SITE  
PLAN-  
PROPOSED

10406 NE Bell

10406, NE 17TH  
ST, BELLEVUE,  
WA 98004

DESIGN REVIEW (LD  
PERMIT)  
22-113250-DC

City of Bellevue  
Driveway Standard Drawings SW-180-1

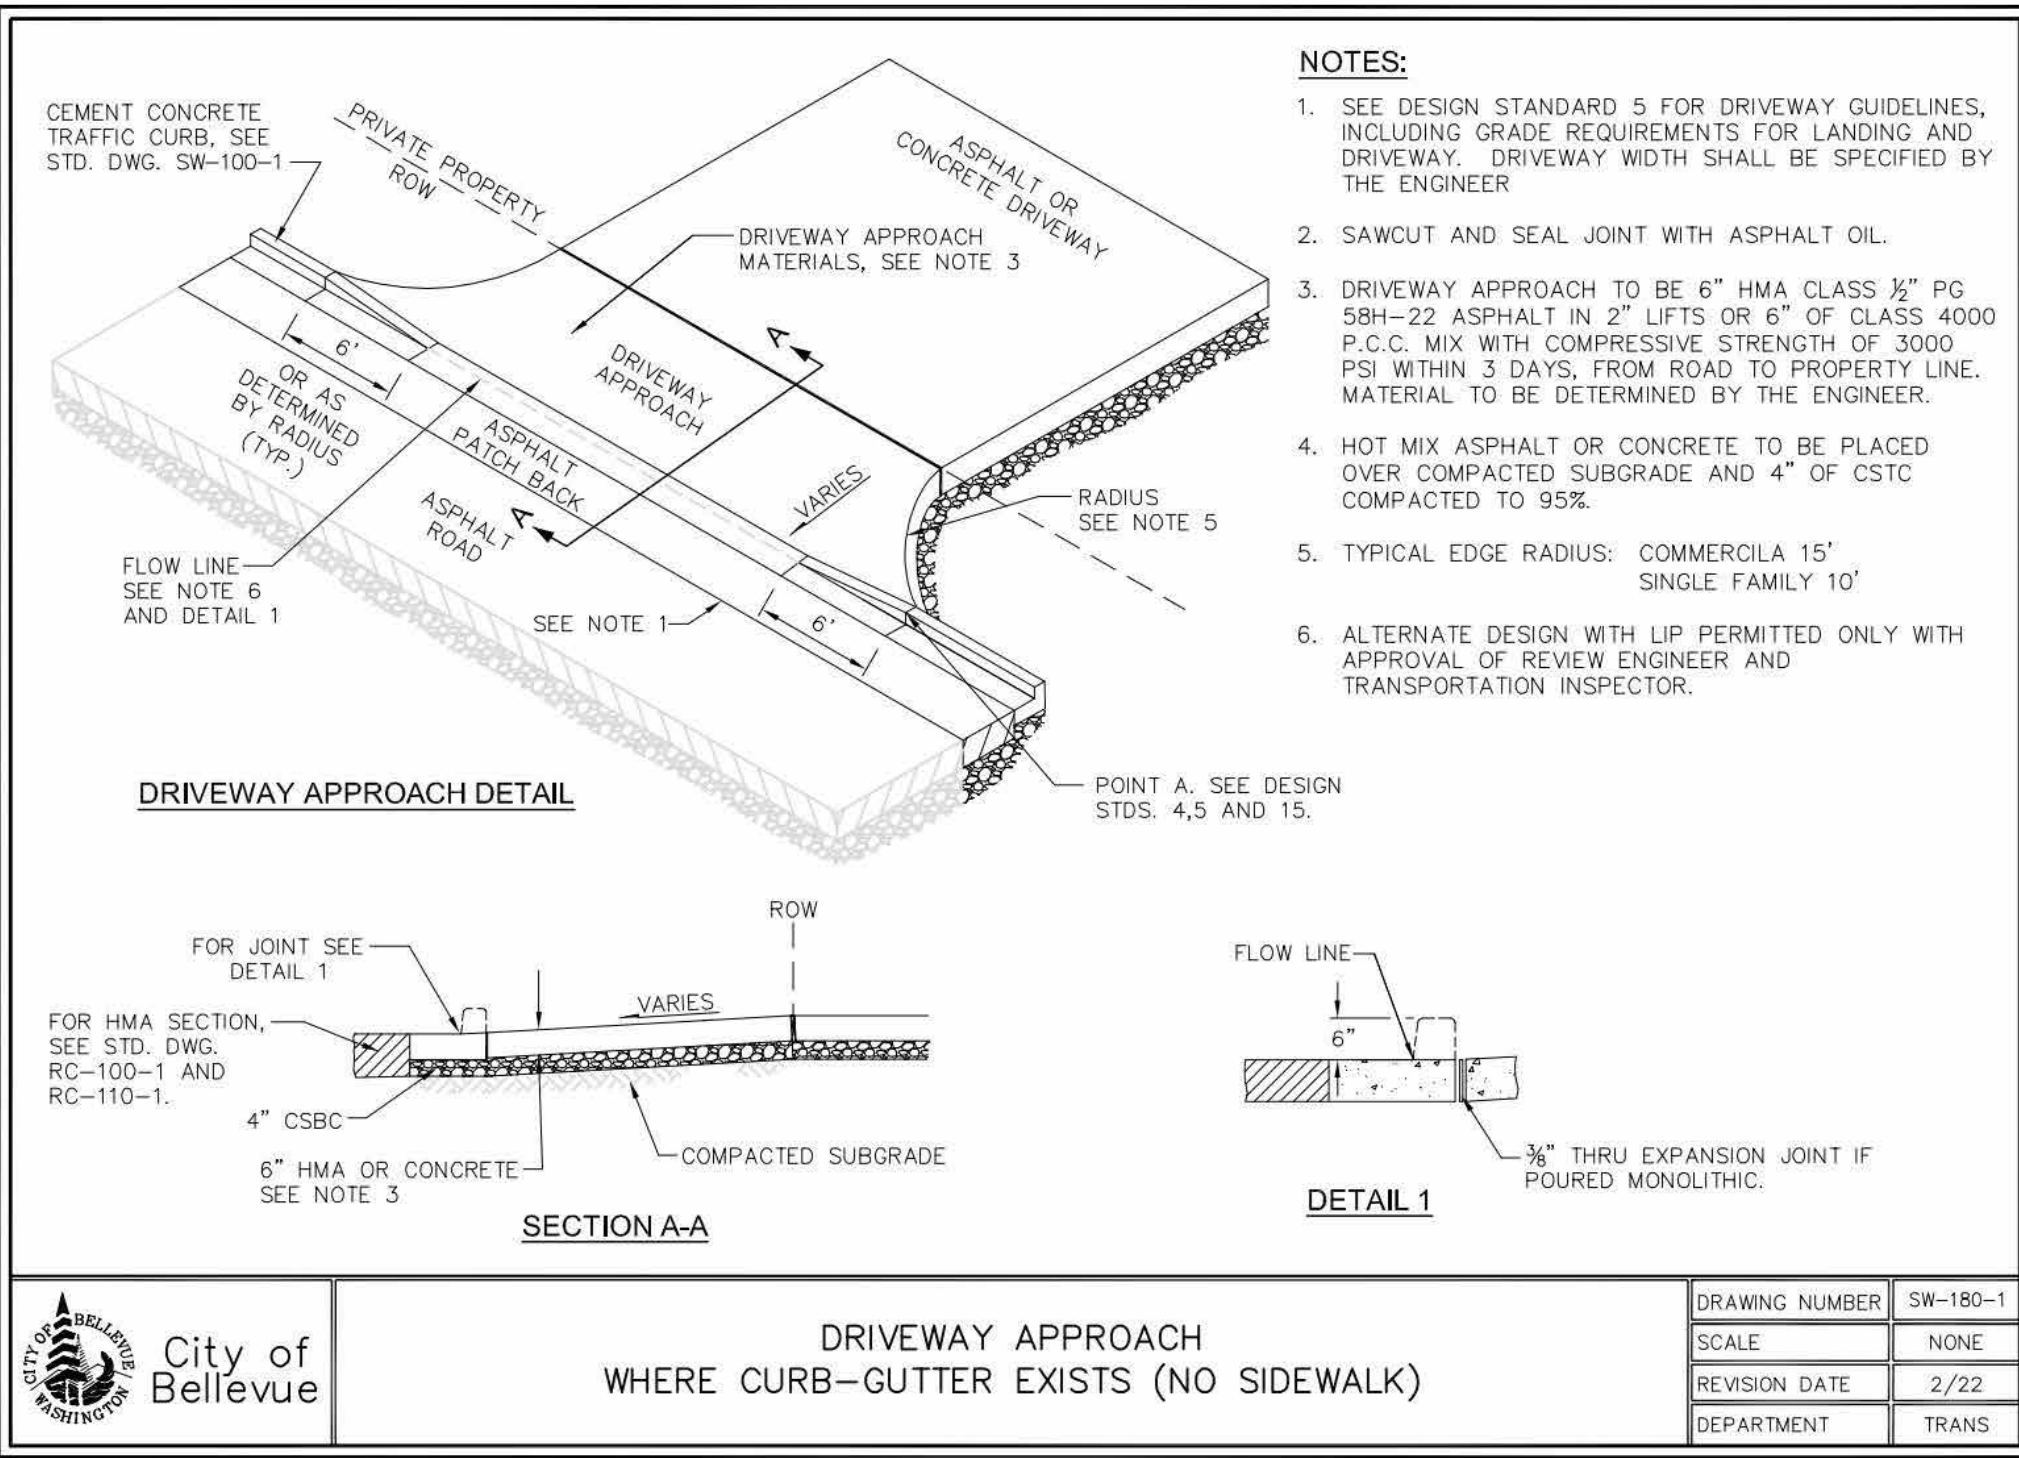
4. The site plan shall match all other Civil Plans/Storm Water Site Plan submitted to the permit for review.
  5. The driveway shall be designed in accordance with the City of Bellevue Design Manual and Transportation Design Manual Drawings SW-180-1. The standard drawing shall be referenced and copied to the Site Plan.

2 Site Plan - Proposed  
3/32" = 1'-0"

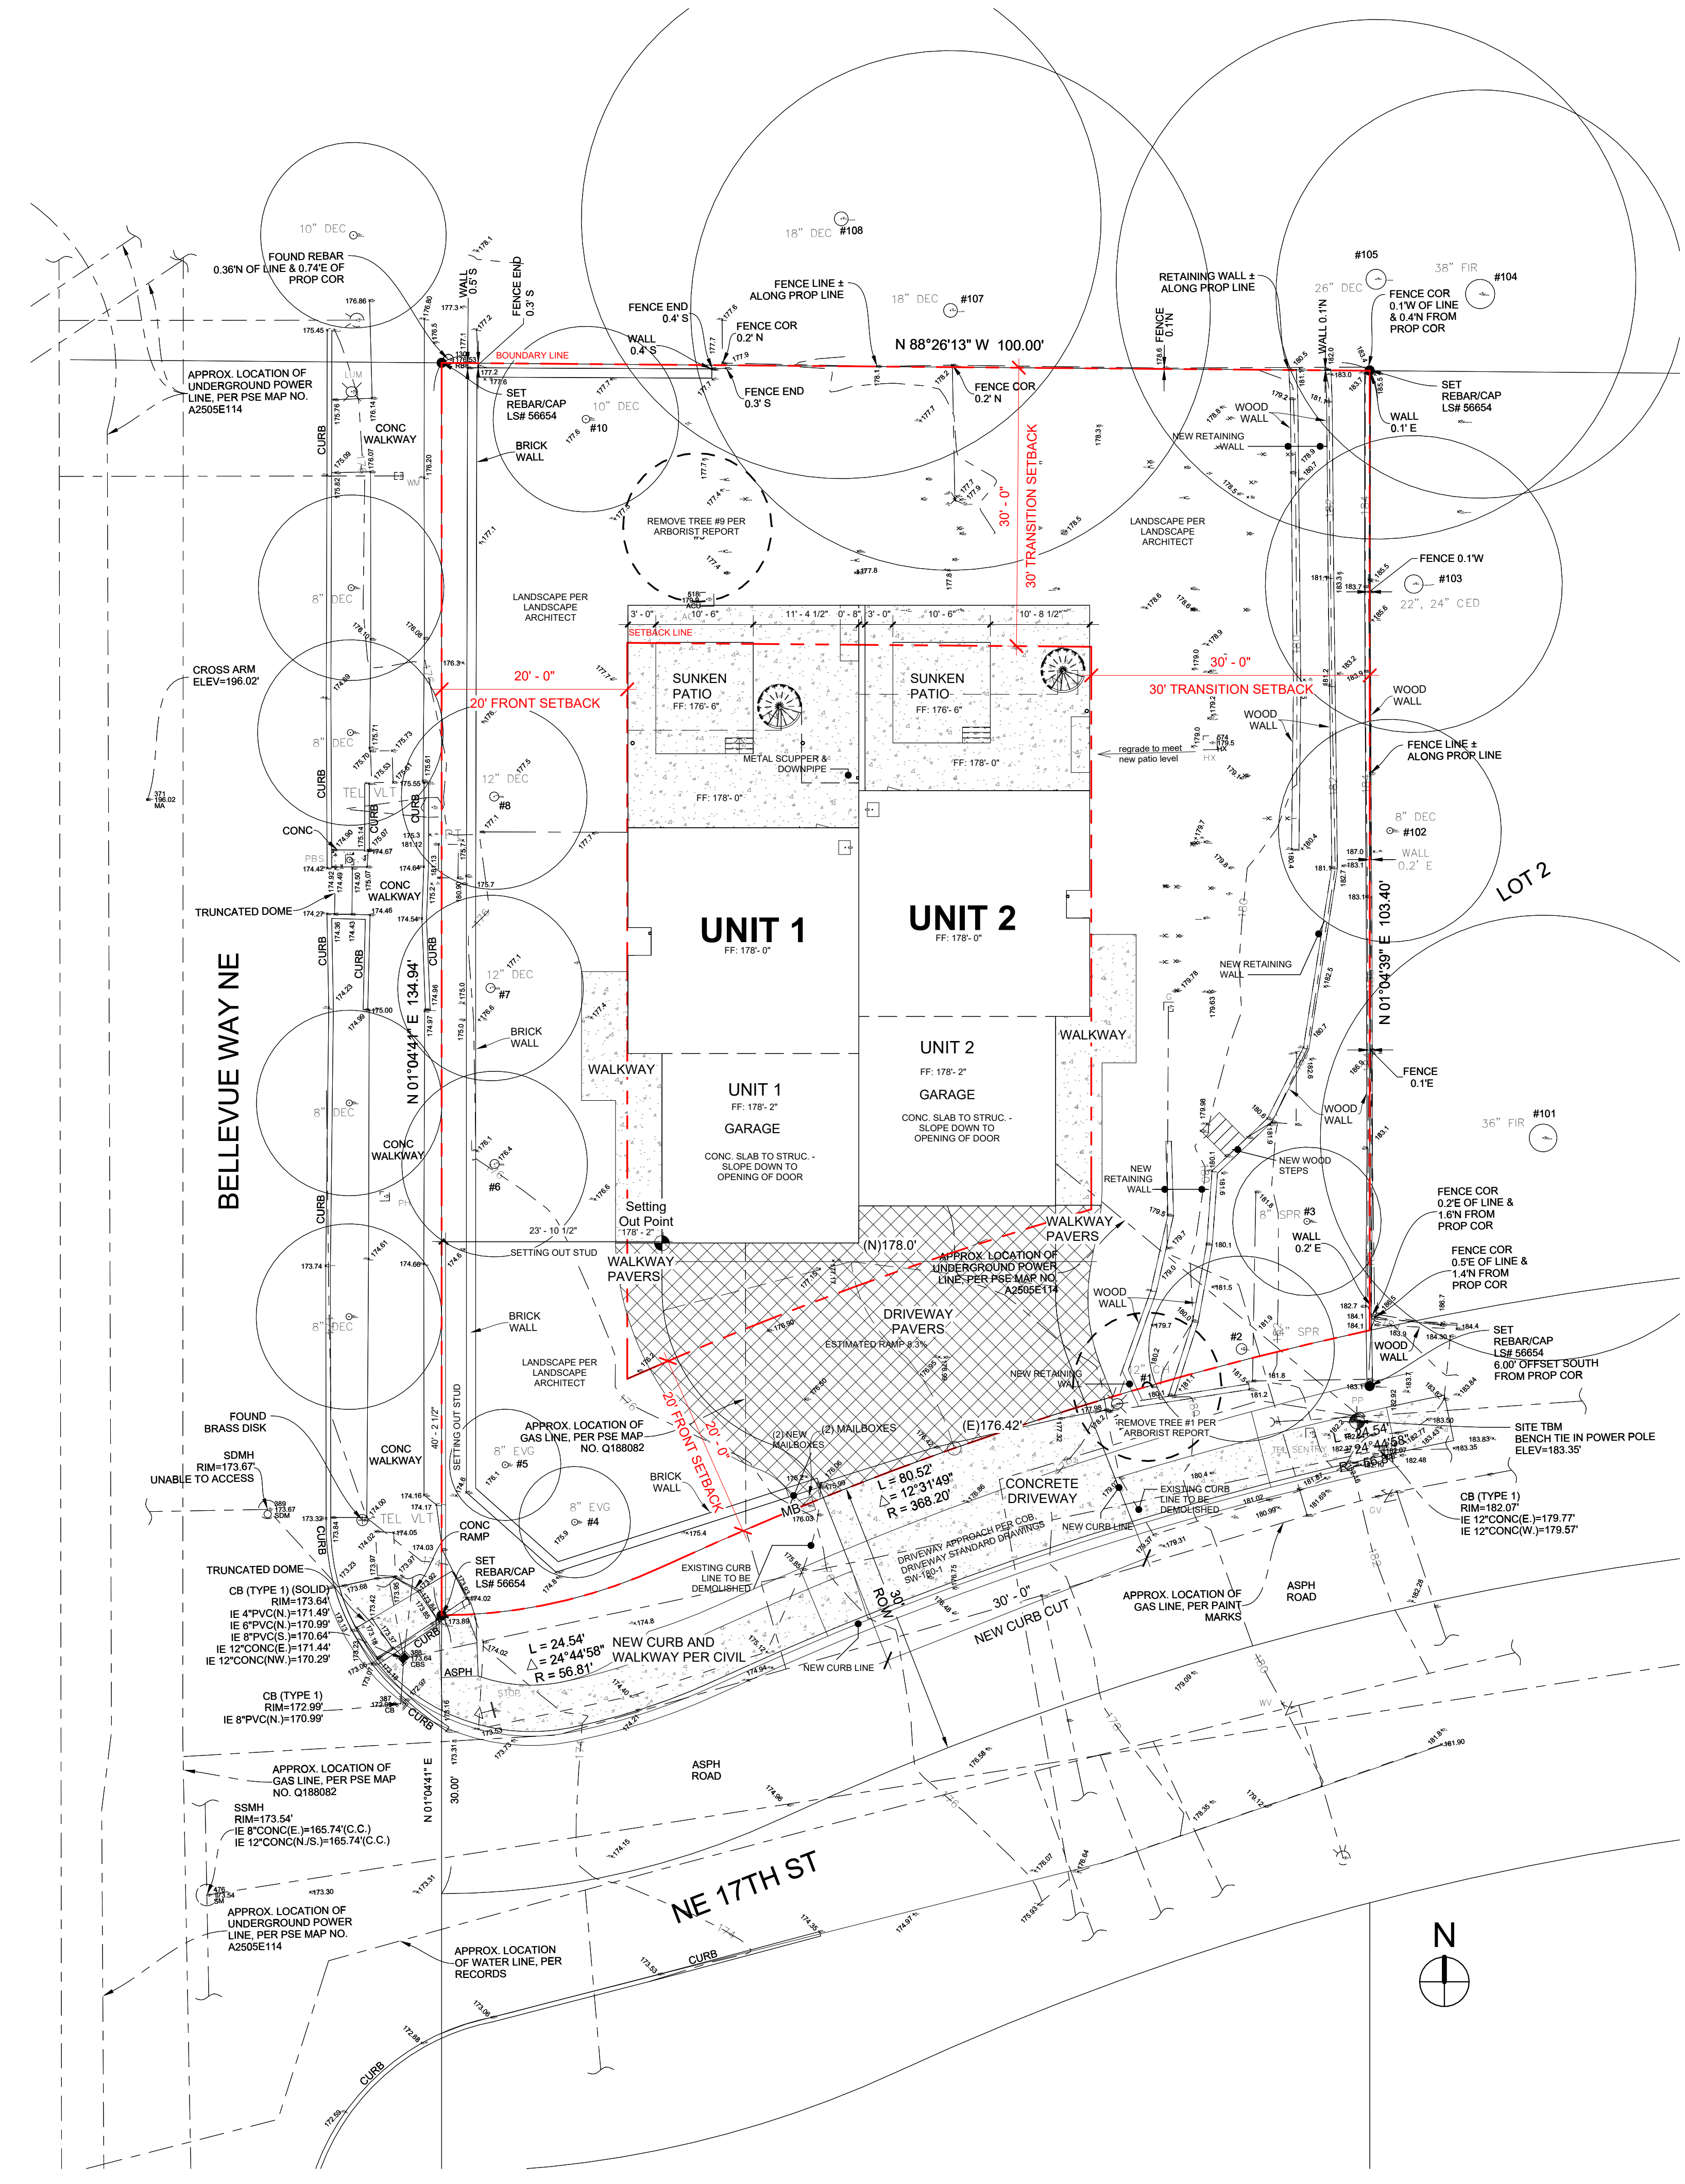
- The following comments are related to the Residential Site Plan
1. Site plan shall illustrate all existing/proposed utilities in the ROW. "FYI, Angled crossings will not be permitted within the ROW." This is mainly for clear and grade review as all trenching for the project shall be shown on the BS permits. We understand this path could be preliminary so this may be noted on the plans as ROW approval for this will be on the separate permits applied for by the individual franchise companies

2. Site plan shall illustrate the new limits of the curb, and gutter, driveway width, and driveway limits including the edge of the radiuses.
  3. All proposed work in the ROW shall be illustrated on the site plan including the trench restoration.

6. FYI, the trench restoration for 129th NE is Grind and Overlay.
